# IWG Safer Transport of Children in Buses and Coaches

Sixth meeting

OICA

# CRS installation requirements Child Restraint Fixtures (CRF)

# Forward Facing Installation

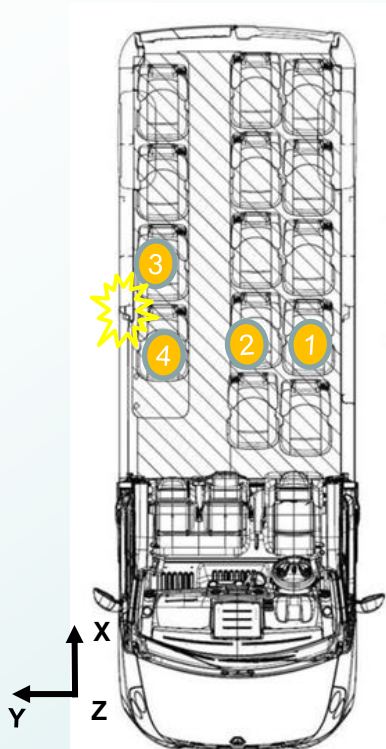
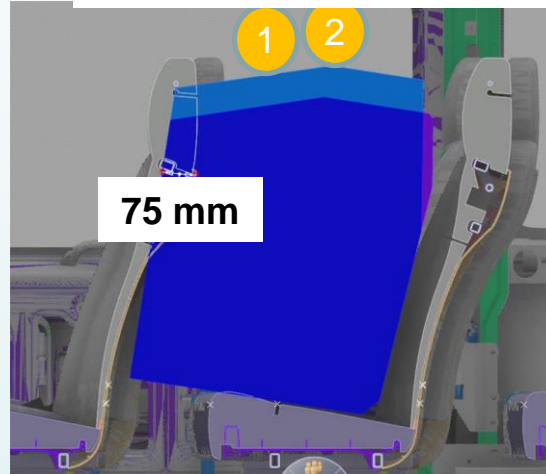
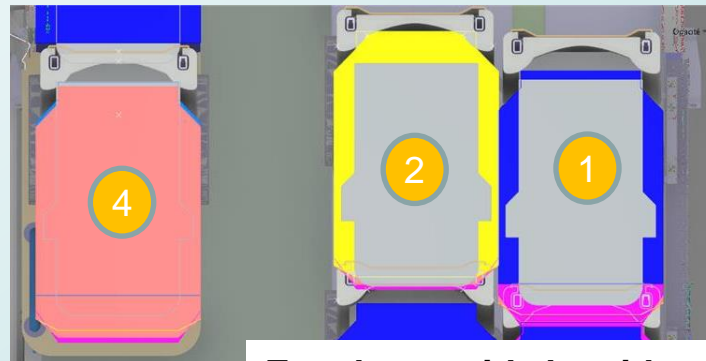
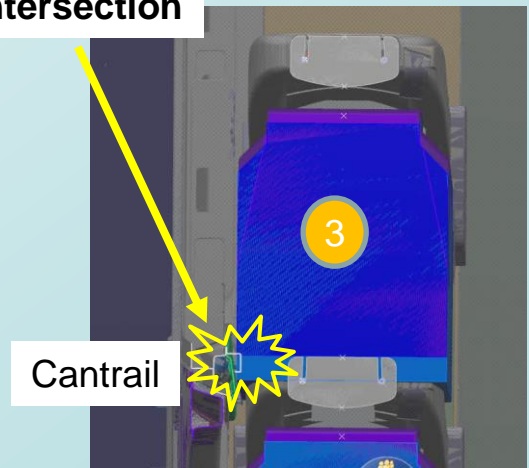
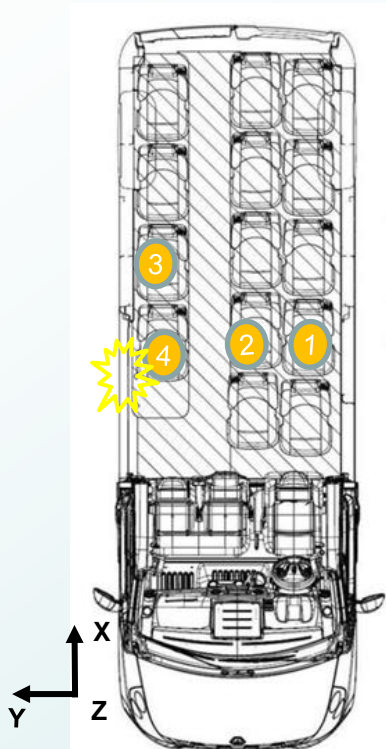
- Envelope/seat overlap
- Intersection w/ Interiors in outermost seats
- Emergency window location

# Forward Facing Installation

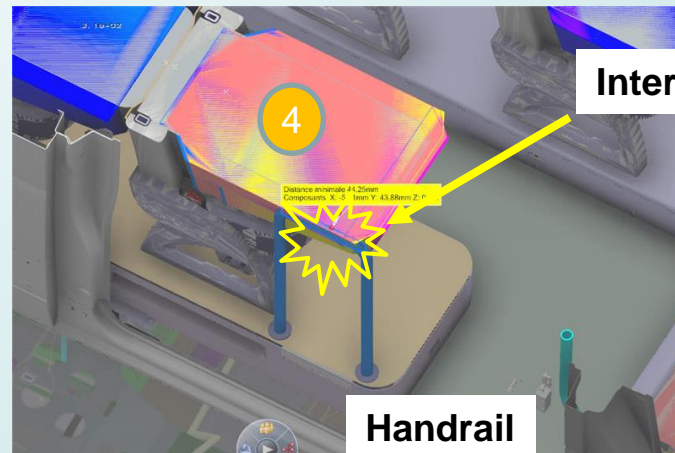
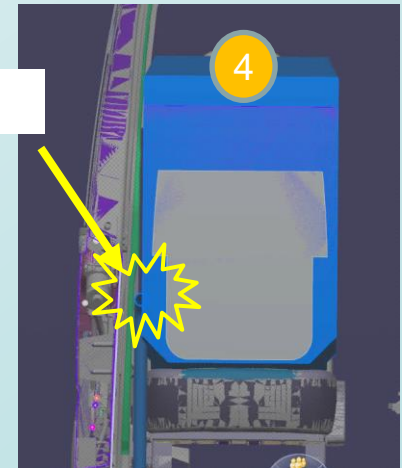
- Intersection w/ handrail

# Rear Facing Installation

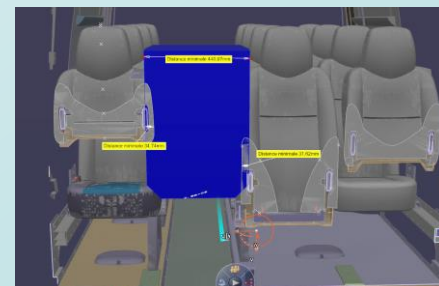
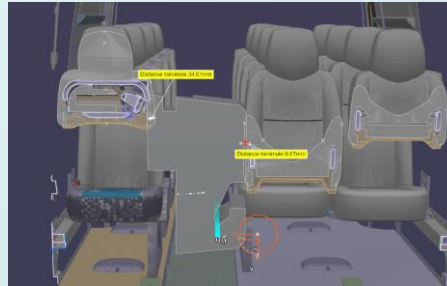
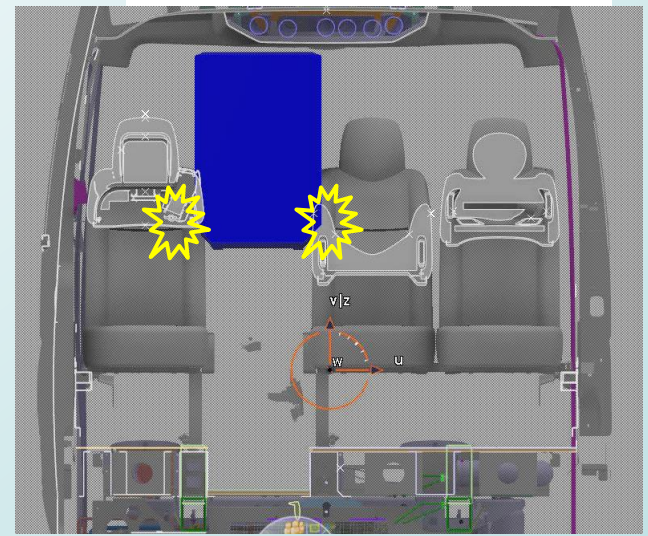
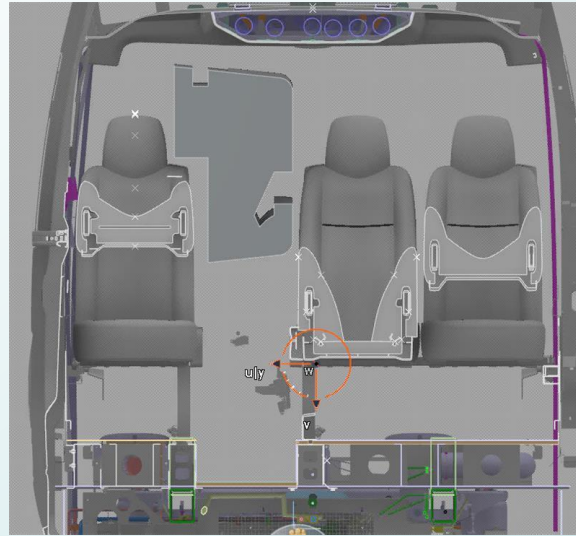
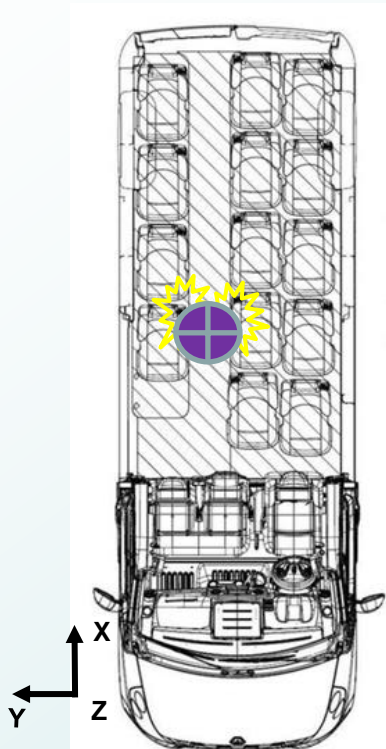
- Envelope/seat overlap
- Intersection w/ Interiors in outermost seats
- Intersection w/ handrail
- Emergency window location
